# UNITED STATES PATENT AND TRADEMARK OFFICE

APPLICATION NO.	FILING DATE	FIRST NAMED INVENTOR	ATTORNEY DOCKET NO.	CONFIRMATION NO	
09/852,974	05/10/2001	Alan Torr	10965/3	4932	
75	90 09/05/2003				
Brinks Hofer Gilson & Lione			EXAMINER		
P.O. Box 10395 Chicago, IL 60			JAGAN, M	JAGAN, MIRELLYS	
			ART UNIT	PAPER NUMBER	
			2859		
			DATE MAILED: 09/05/2003	DATE MAILED: 09/05/2003

RF				
4	Application No		Applicant(s)	-				
	09/852,974		TORR, ALAN					
Office Action Summary	Examin r		Art Unit					
	Mirellys Jagan		2859					
The MAILING DATE of this communication appears on the cover sheet with the corr spondence address Period for Reply								
A SHORTENED STATUTORY PERIOD FOR REPITHE MAILING DATE OF THIS COMMUNICATION  - Extensions of time may be available under the provisions of 37 CFR 1 after SIX (6) MONTHS from the mailing date of this communication.  - If the period for reply specified above is less than thirty (30) days, a re  - If NO period for reply is specified above, the maximum statutory period  - Failure to reply within the set or extended period for reply will, by statu  - Any reply received by the Office later than three months after the mailing earned patent term ad

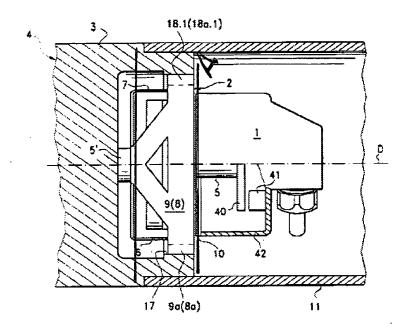
Applicant's argument that Feichtinger fails to anticipate claims 17 and 20 because Feichtinger fails to disclose a contact face that extends transversely to an axis of a rotor and engages a contact face of a coupler is not persuasive.

Referring to claim 17, applicant's argument is not persuasive since Feichtinger disclose a stator having a contact face (A) that extends transversely to an axis (D) of a rotor and engages a contact face (the inside surface of the framework formed by 13-16) of a coupler (2) (see the figure below).
